Re: Request for Minor Plan Change
MassDEP File No. 159-1264
Grove Street Shared Use Path & Roadway Improvements
Franklin, MA

On behalf of the Town of Franklin Department of Public Works (DPW), BETA Group, Inc. (BETA) is submitting this Request for a Minor Plan Change in association with Phase 2 of the Grove Street Shared Use Path & Improvements Project (the Project). The Project received an Order of Conditions (OOC) from the Franklin Conservation Commission on April 10, 2023.

Attachment A: Revised Plan Sheets

RESOURCE AREA PLAN 7

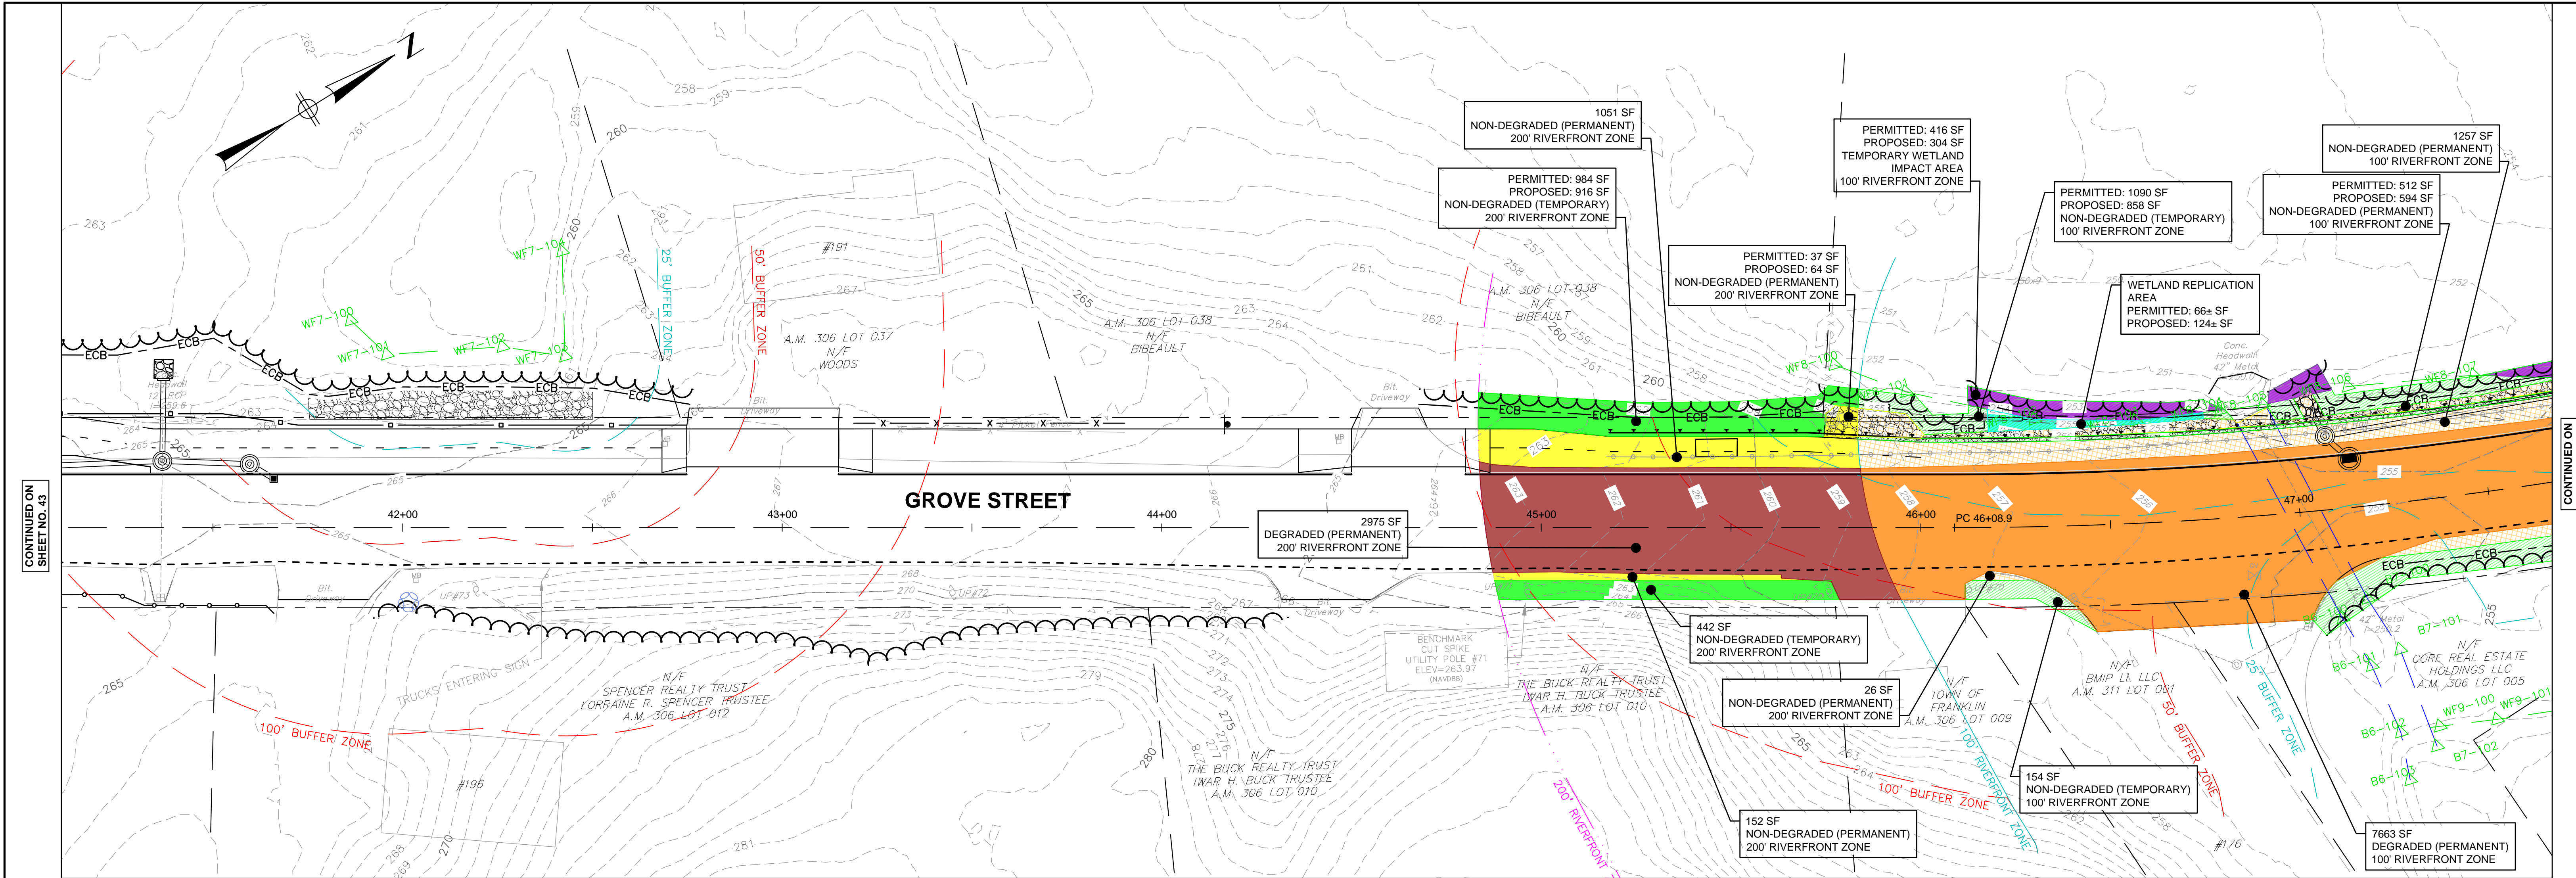
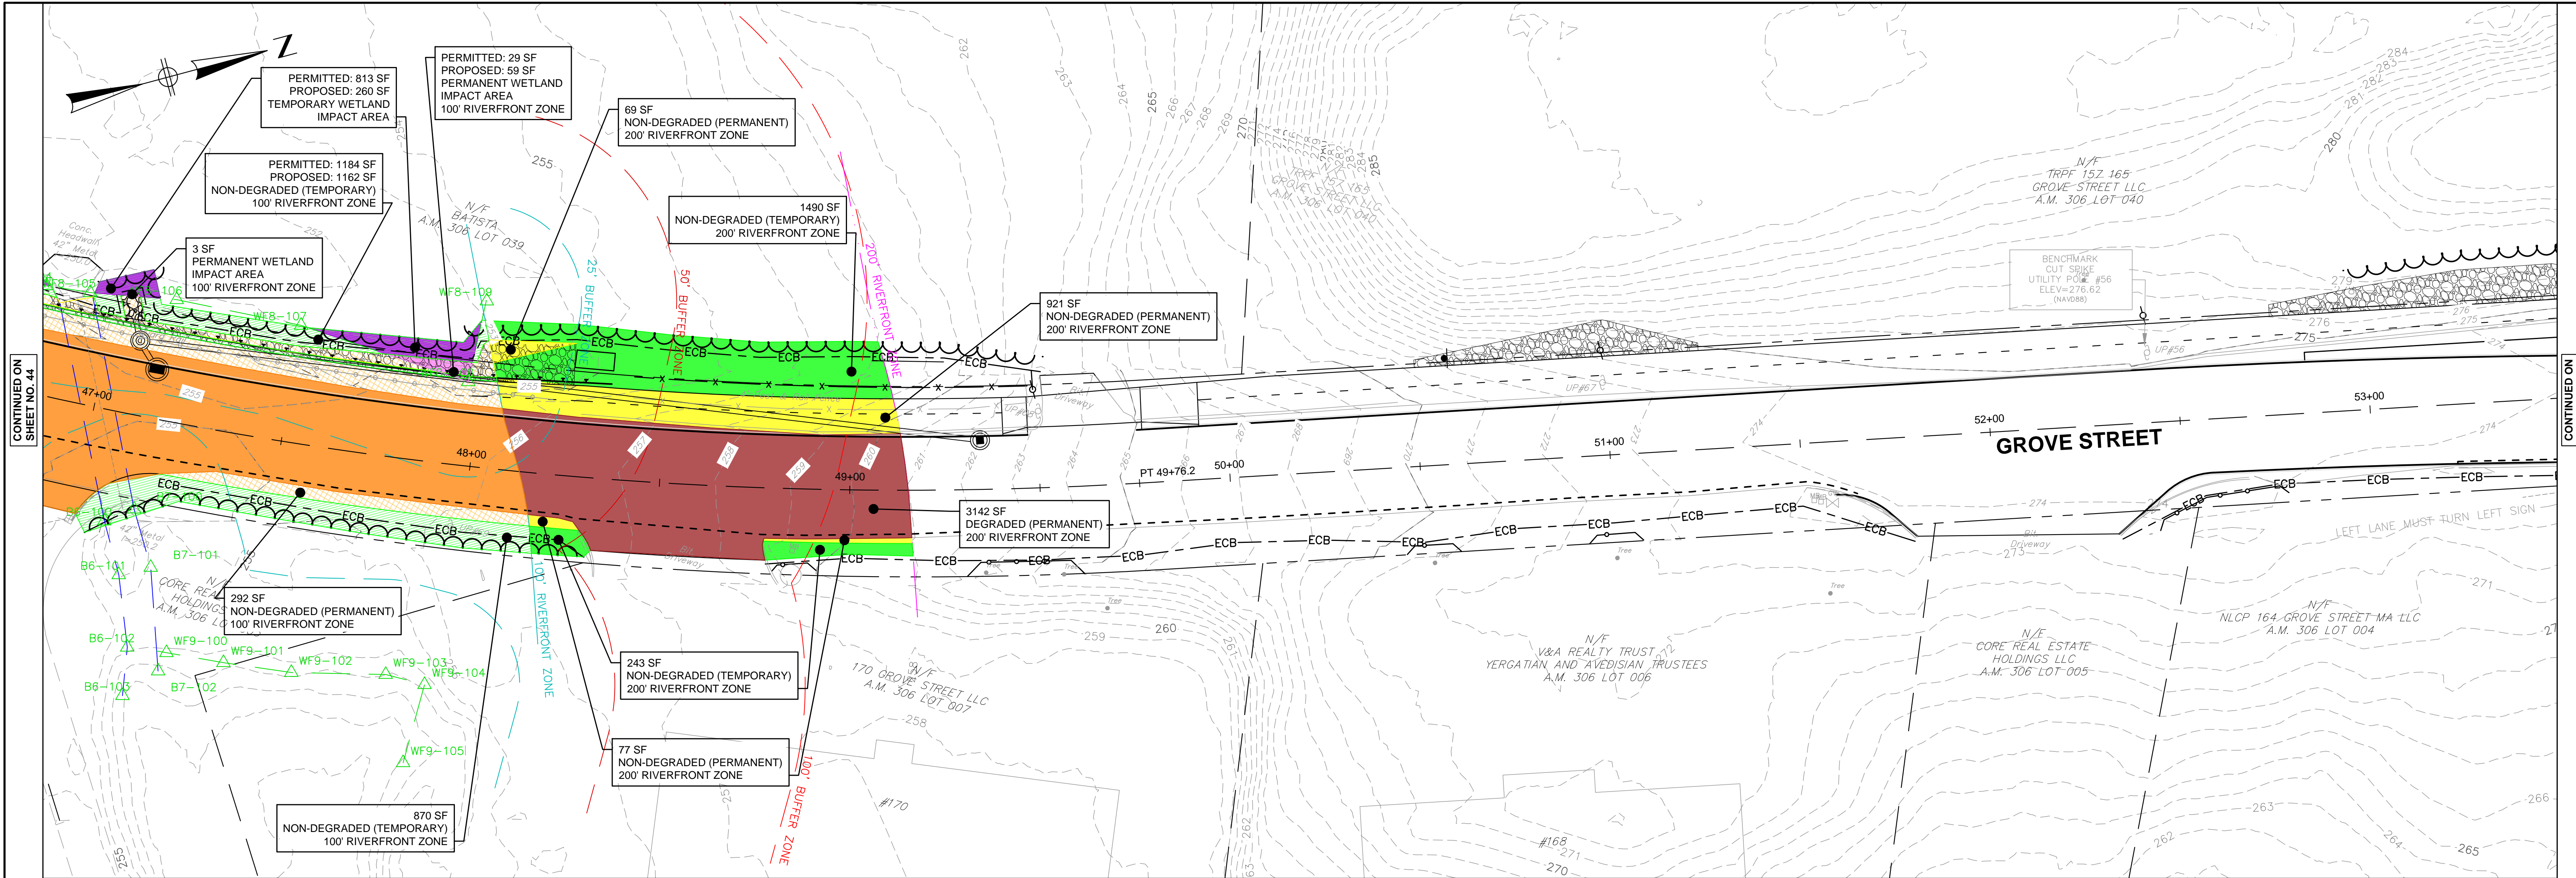
Following the issuance of the OOC and receiving the Town's comments on the 100% design, it was determined that a rock fill slope would be preferable to the originally proposed retaining wall at Station 47+00. A rock fill slope would offer far lower construction costs and present a safer alternative that does not create a sudden drop-off along a pedestrian route. The proposed slope would result in 59 square feet of BVW fill opposed to the 29 square feet permitted at this location under the original design. The new total area of permanent BVW impacts being proposed is 62 square feet, which also accounts for the 3 square feet of impacts associated with the placement of stone along an outfall.

Although permanent impacts have been increased, temporary BVW impacts at this location have been reduced from 813 square feet to 260 square feet since the extent of staging required for wall construction will not be required. Under this revised design, the wetland replication area is being increased to 124 square feet as depicted on the attached wetland replication/restoration plan to maintain compliance with the 2:1 replication requirement of the Bylaw. To account for the increase in the size of the replication area, three (3) additional silky dogwood (*Cornus amomum*) plantings are proposed. All temporarily impacted areas of BVW will be restored in place as described in the original Notice of Intent submission.
